UNITED STATES  
NUCLEAR REGULATORY COMMISSION

SUBJECT: SAFETY ASSESSMENT OF REPORT CEN-604 REVISION 01, "FINAL EVALUATION OF LOW UPPER SHELF ENERGY FOR COMBUSTION ENGINEERING NUCLEAR STEAM SUPPLY SYSTEMS REACTOR PRESSURE VESSELS, FINAL REPORT," SEPTEMBER 1993

### SAFETY ASSESSMENT BY THE OFFICE OF NUCLEAR REACTOR REGULATION REACTOR VESSEL UPPER SHELF BOUNDING EQUIVALENT MARGINS ANALYSIS FOR COMBUSTION ENGINEERING OWNERS GROUP PRESSURIZED WATER REACTORS CEN-604, REVISION 01

Figure 1  
 J-INTEGRAL VS. CRACK DEPTH  
 100 F/HR CD, PRESSURE = 2750 psia  
 AXIAL FLAW ORIENTATION, LEVEL A, PLATE MATERIAL  
 VESSEL SIZE: NOMINAL ID = 182 in, BELTLINE THICKNESS = 9.06 in  
 FLAW GROWTH

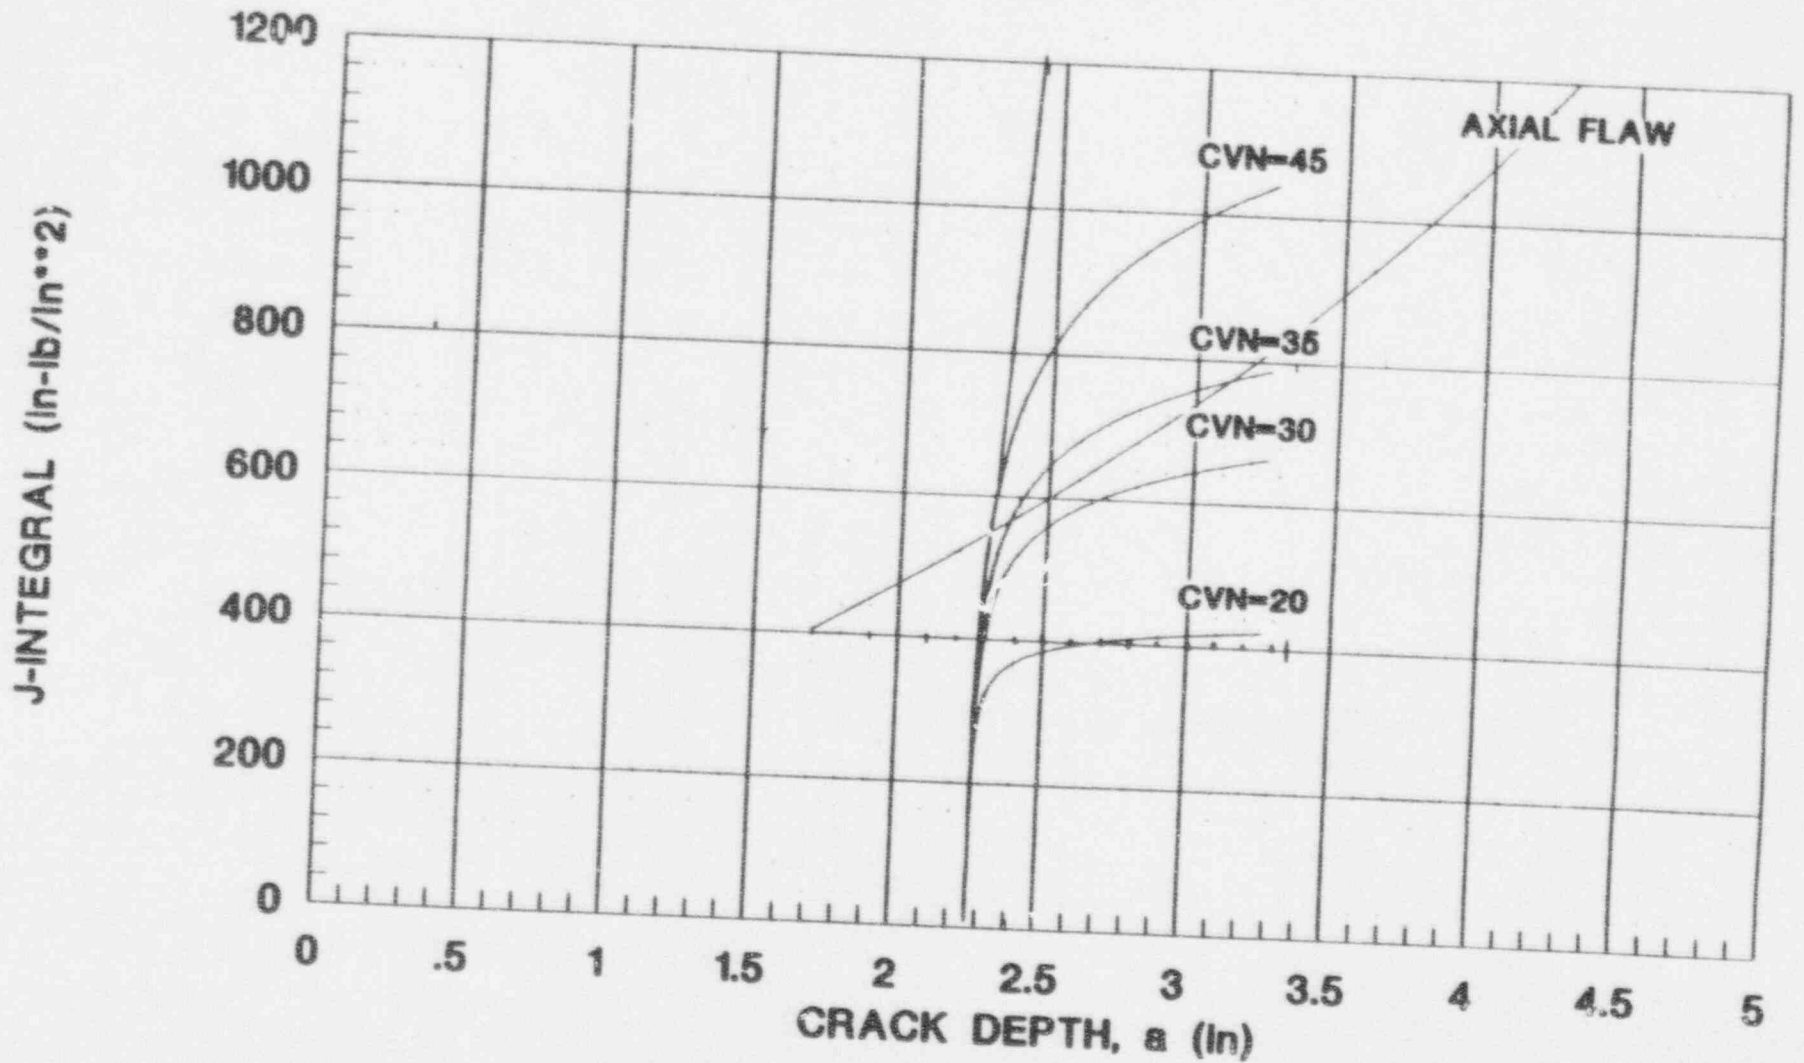
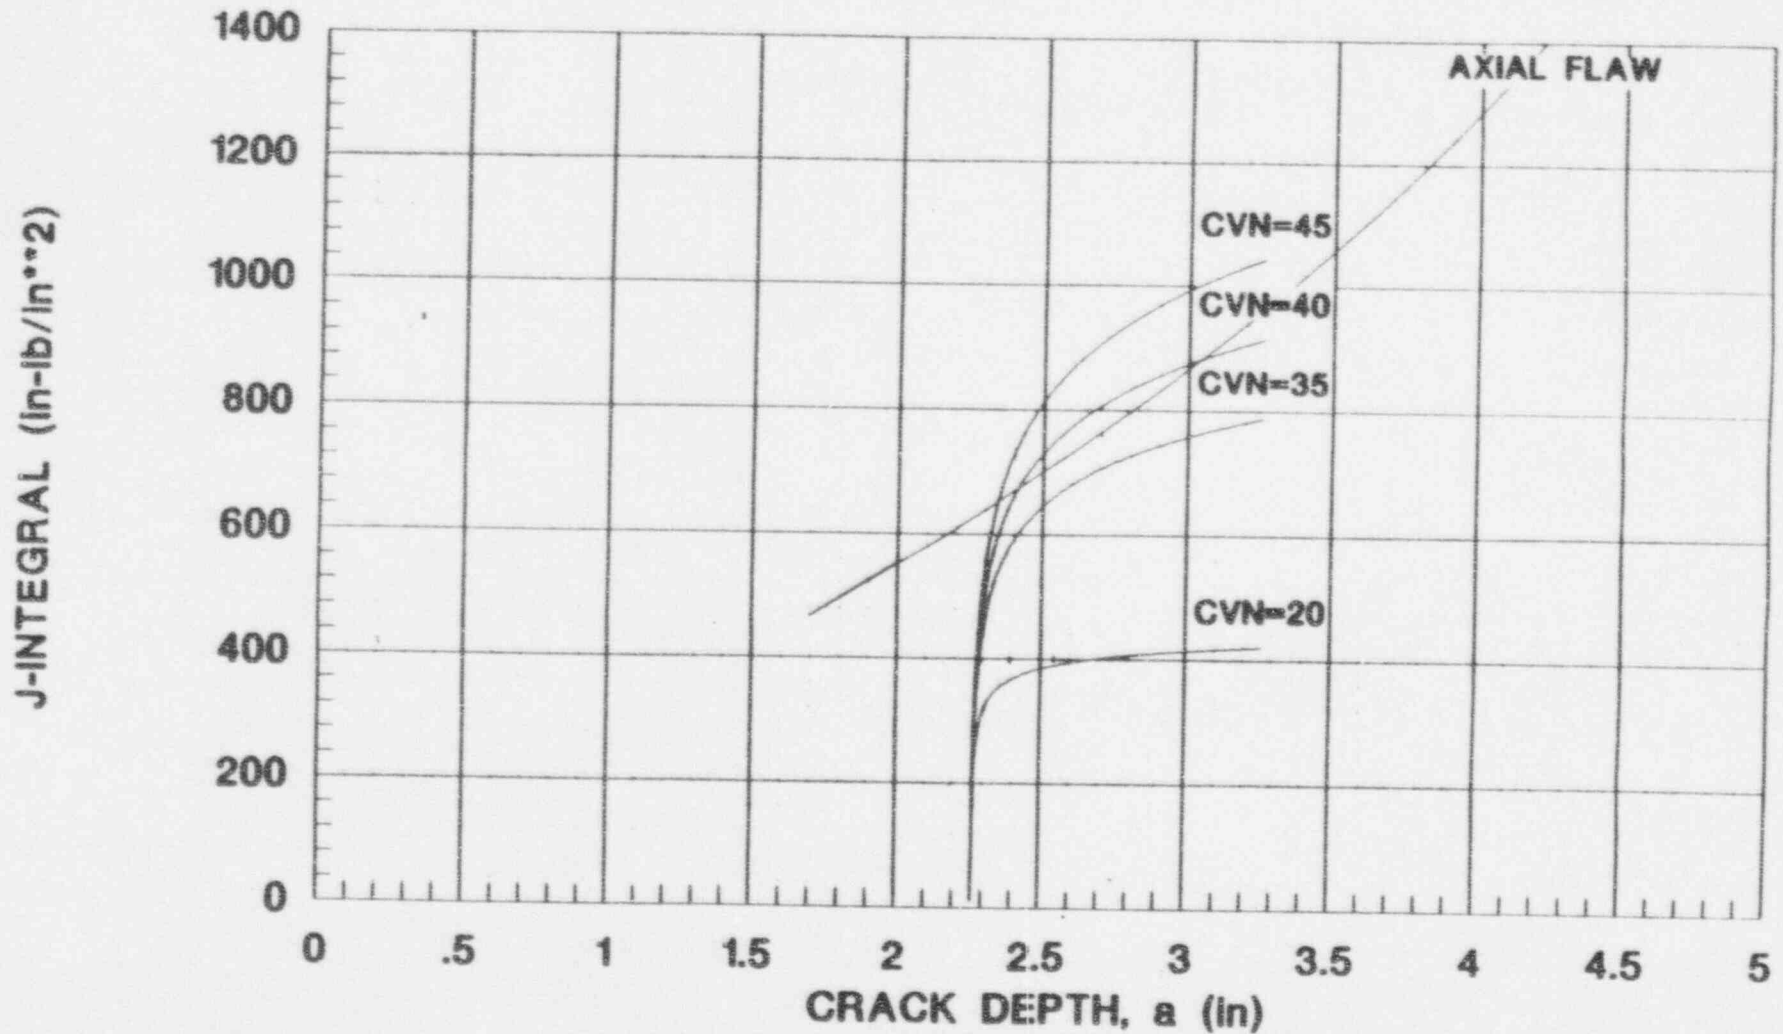
The bounding results of the CEOG analysis are presented in Figures 1 through 4 [1]. The bounding Level A & B case was found to be for the largest reactor vessel (nominal inside diameter = 182 inches, wall thickness = 9.06 inches) with consideration of the axial flaw. The CEOG considered the material temperature at 550°F. Figure 1 presents the bounding Level A case evaluated against the flaw growth criterion (criterion 1) of Code Case N-512 [3]. The intersection of the  $J_{\text{applied}}$  and J-R curves at 0.1 inches of crack extension occurs for a USE of 35 ft-lbs. In Figure 2, a similar evaluation considering the flaw stability criterion (criterion 2) of the code case indicates a tangency (instability) point for a J-R curve at approximately the 38 ft-lb level. The CEOG therefore concluded that criterion 2 was controlling and that 38 ft-lbs was the bounding USE level for the equivalent margins analysis.

Figure 3  
J-INTEGRAL VS. CRACK DEPTH  
STEAM LINE BREAK  
AXIAL FLAW ORIENTATION, LEVEL C, PLATE MATERIAL

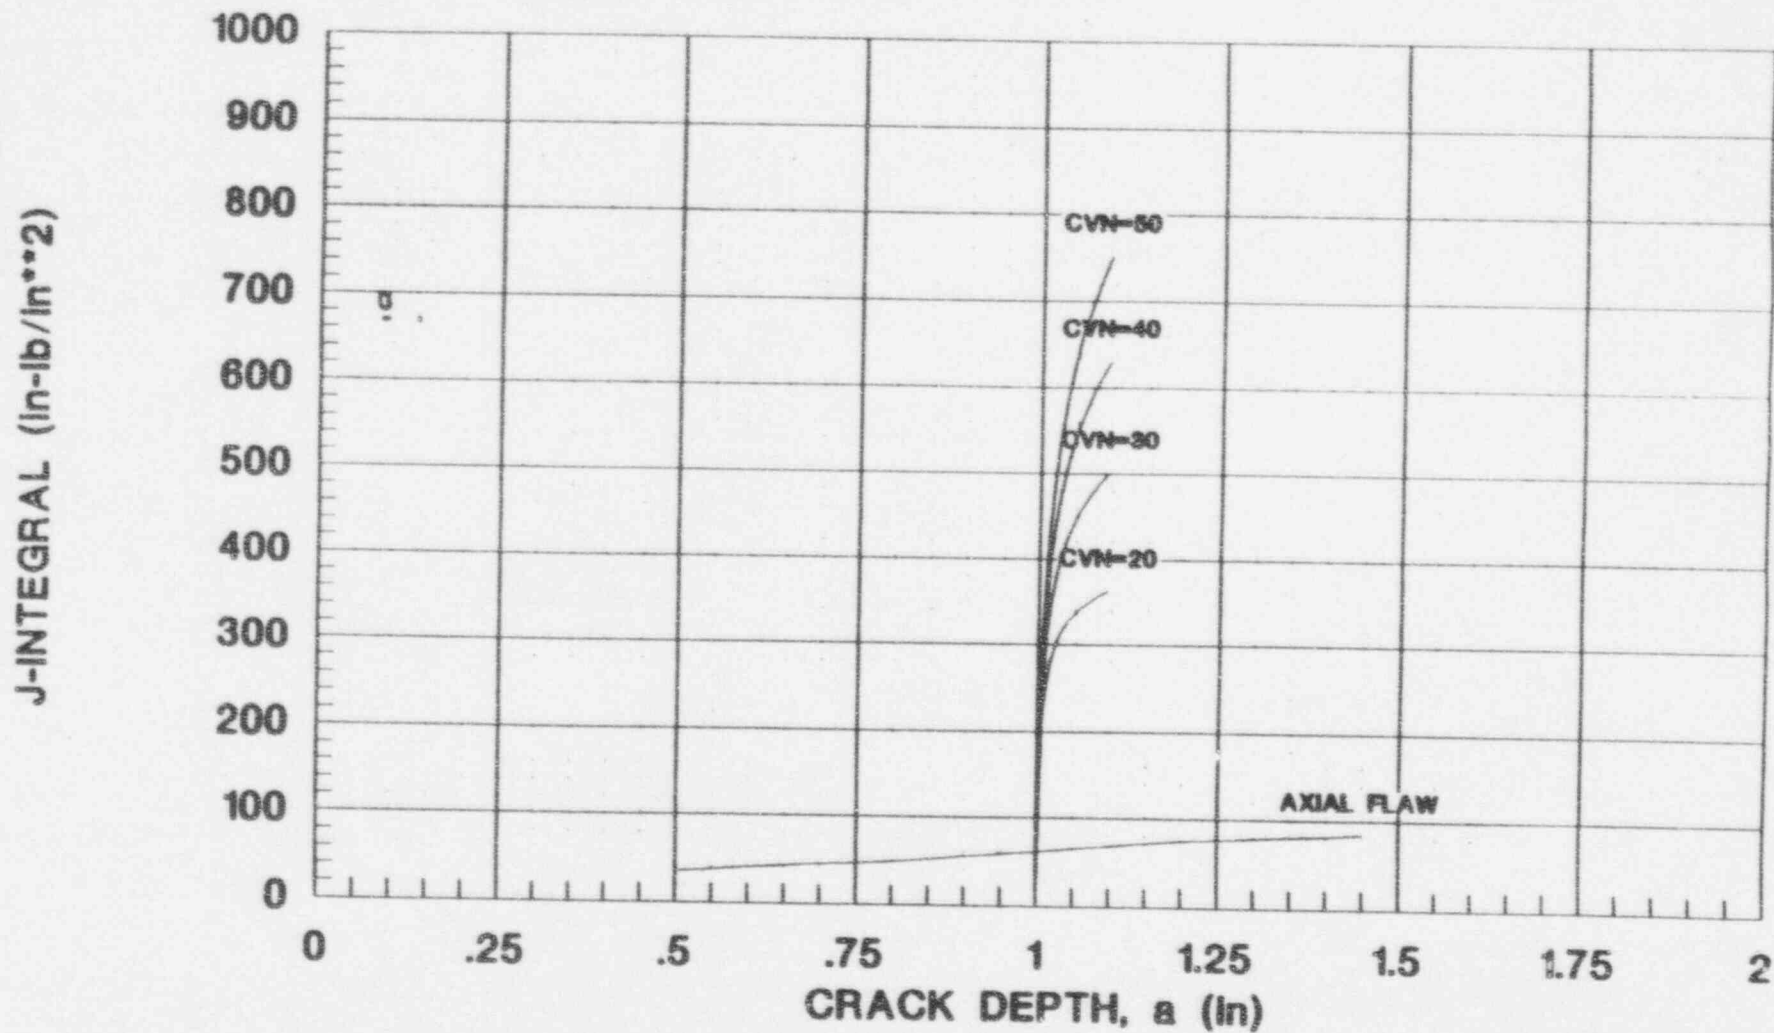
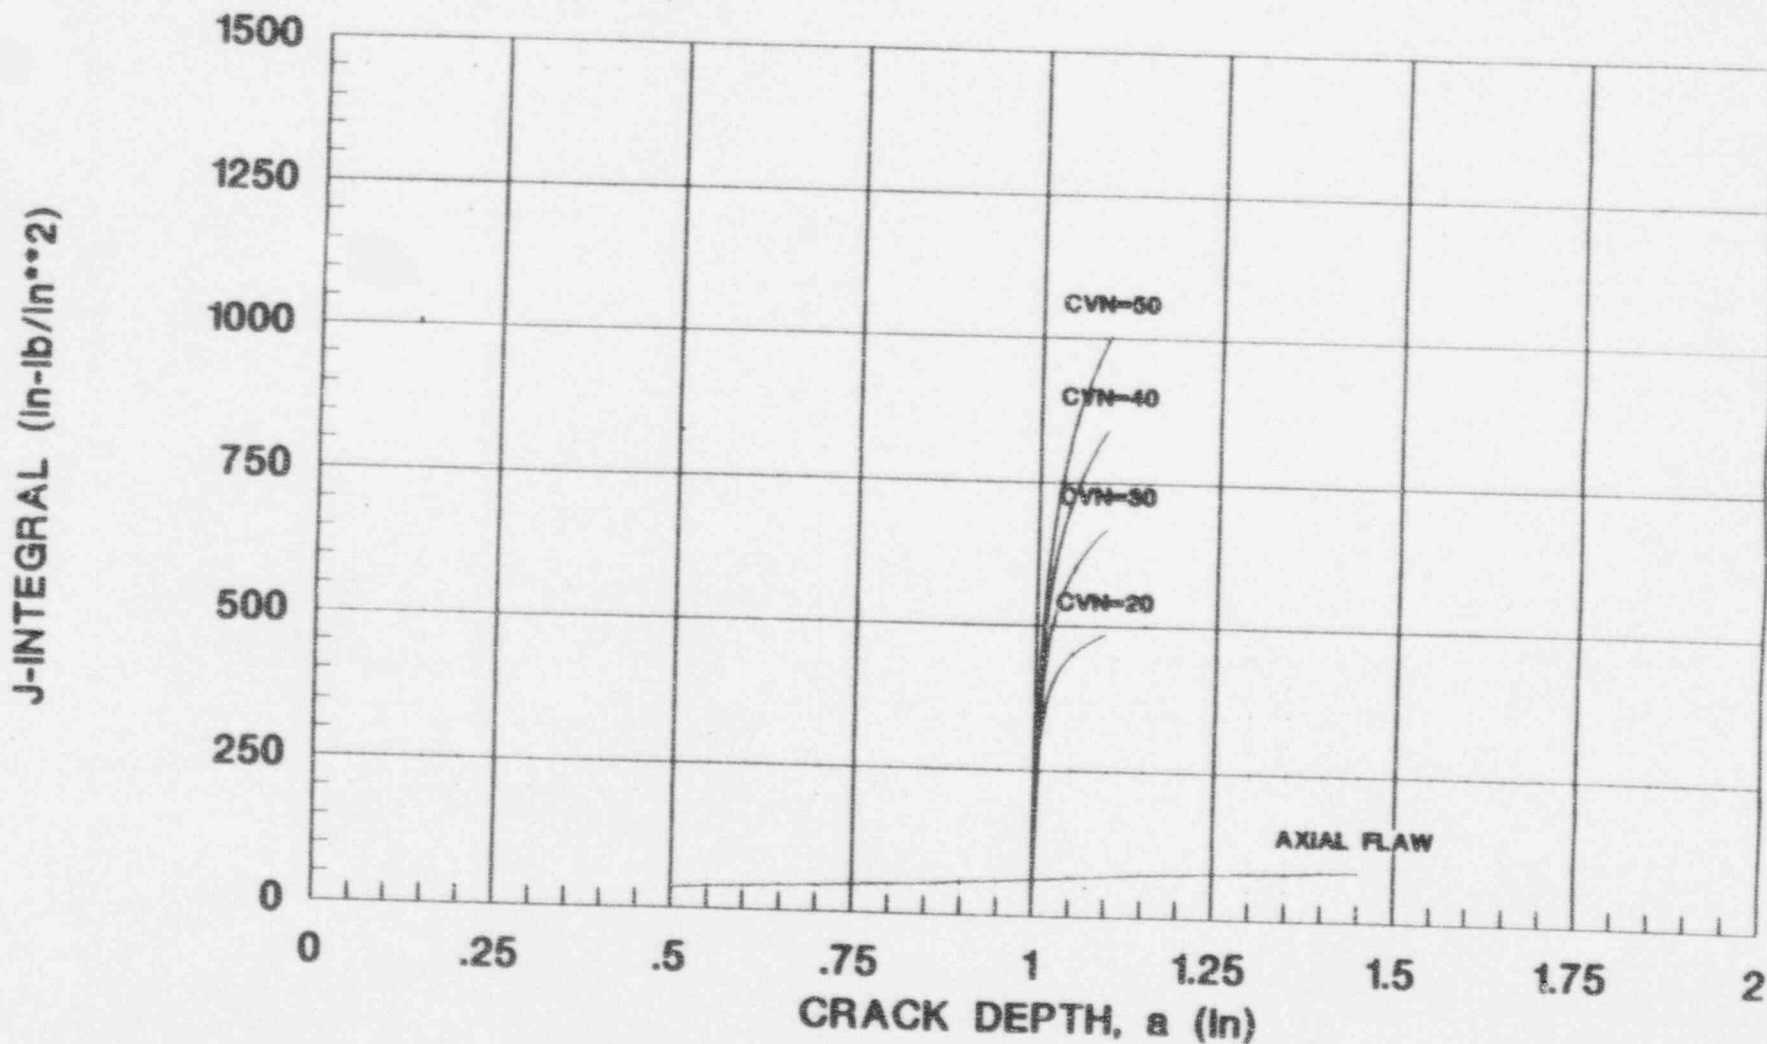
The bounding Level C & D transient (SLB) was considered against the flaw growth criterion of Code Case N-512 in Figures 3 and 4 [1]. An evaluation against the flaw stability criterion was not provided for either case as required by the Code Case. However, due to the extremely low  $J_{\text{applied}}$  values obtained for these the Level C & D transients, it is readily shown that Levels A & B are controlling for the equivalent margins analysis.

Figure 5

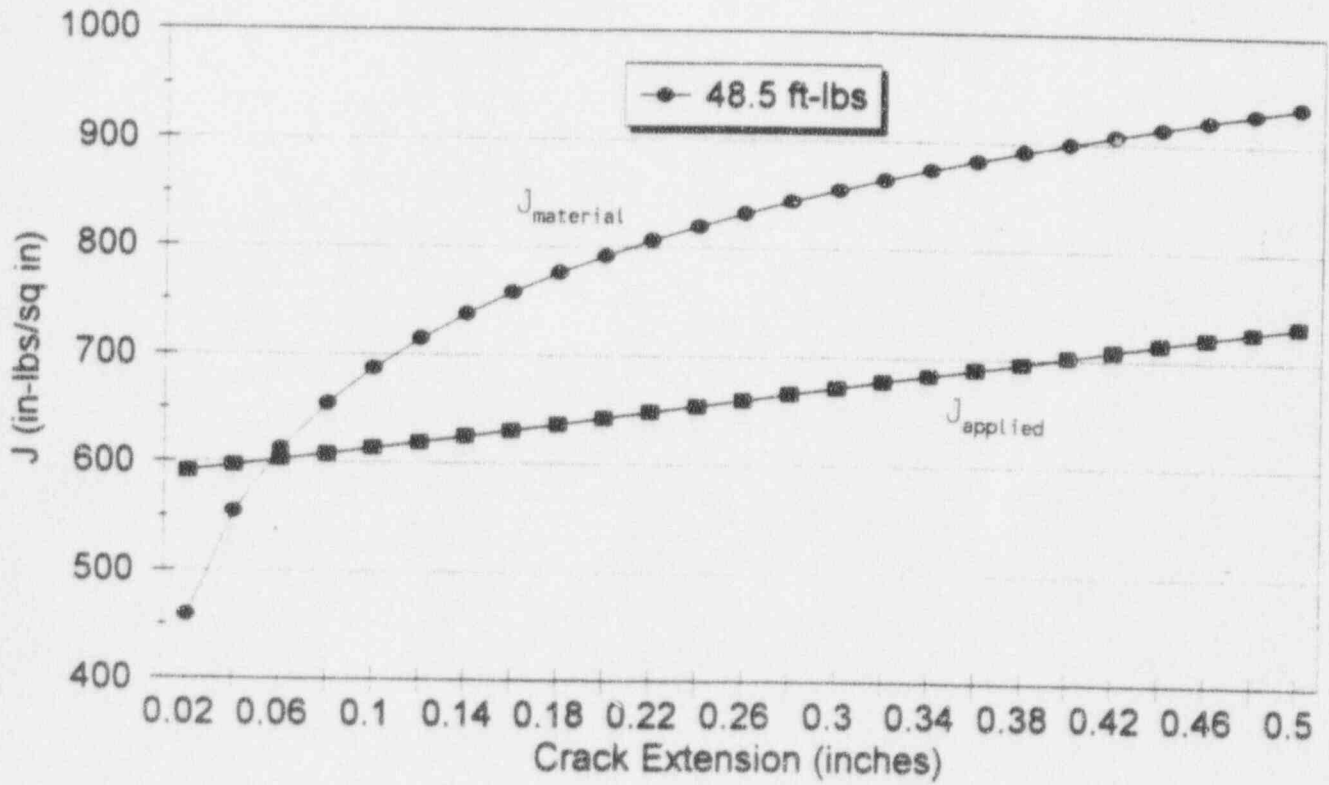
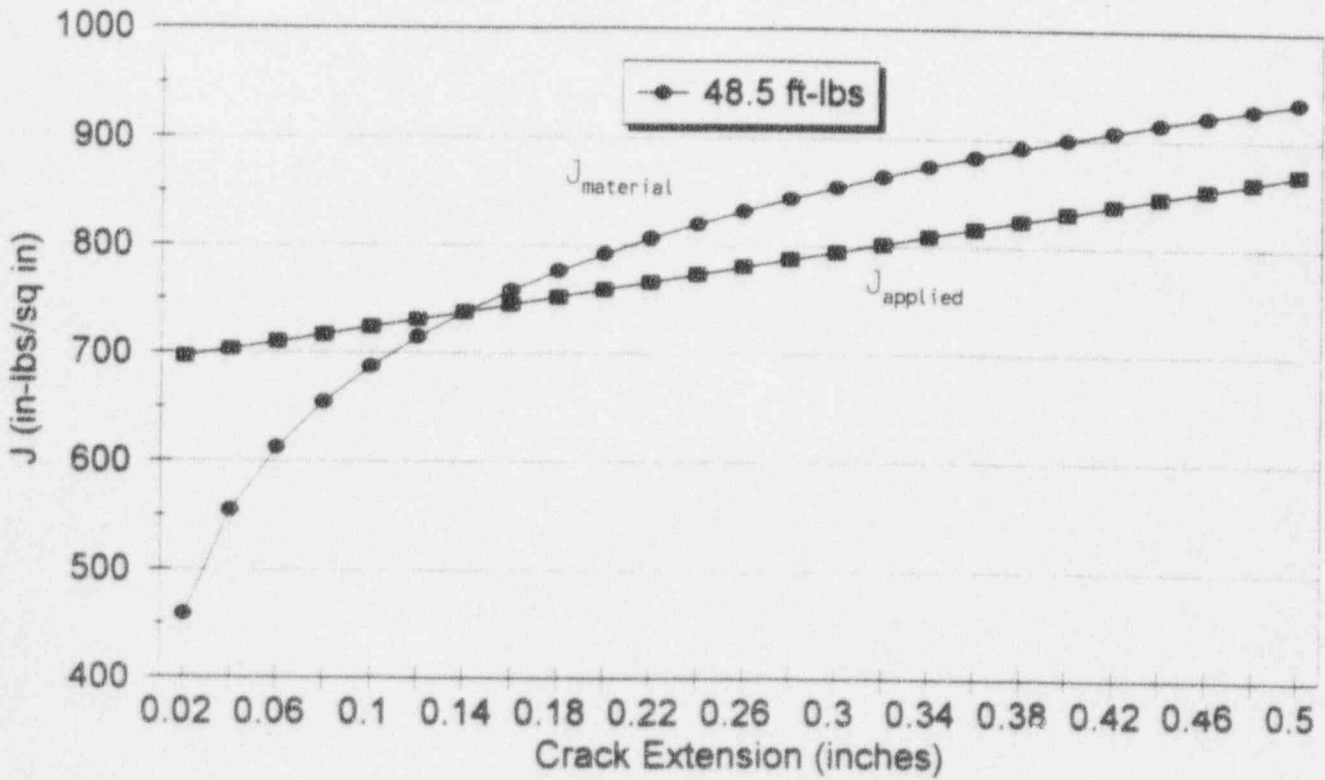
The results of the independent analysis performed by the staff are presented in Figures 5 through 8. Figures 5 and 6 show the J-R curves for the lowest projected USE level of 48.5 ft-lbs and the  $J_{\text{applied}}$  curves computed using the material inputs as described in Section 3.1, compared against the criteria of the Code Case. The staff analysis shows that a USE of 48.5 ft-lbs exceeds the requirements of Code Case N-512.

Based on this analysis, the staff has concluded that a USE of approximately 45 ft-lbs would be limiting based on an axially oriented flaw for the limiting CEOG material and vessel geometry. As the limiting CEOG beltline plate was demonstrated to exhibit 48.5 ft-lbs at EOL, the staff has concluded that the subject report demonstrates equivalent margins of safety to the ASME Code, Appendix G for CEOG plate materials.

Figure 7

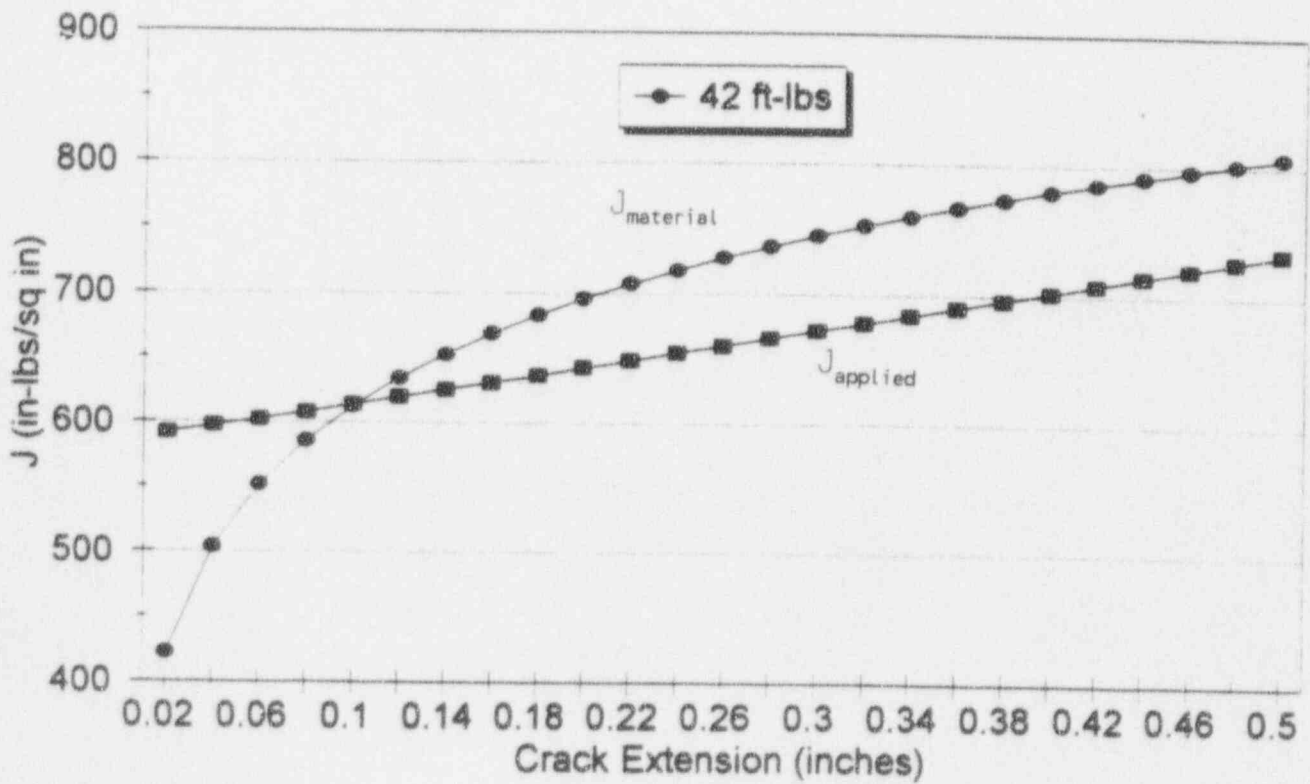
Figures 7 and 8 show the J-R curves for "bounding" projected USE levels and the  $J_{\text{applied}}$  curves computed using the material inputs as described in Section 3.1, compared against the criteria of the Code Case. This analysis shows 42 ft-lbs to be controlling for criterion 1 (flaw growth) while 45 ft-lbs controls for criterion 2 (flaw stability). This compares to 35 ft-lbs and 38 ft-lbs, respectively as determined from the CEOG analysis.
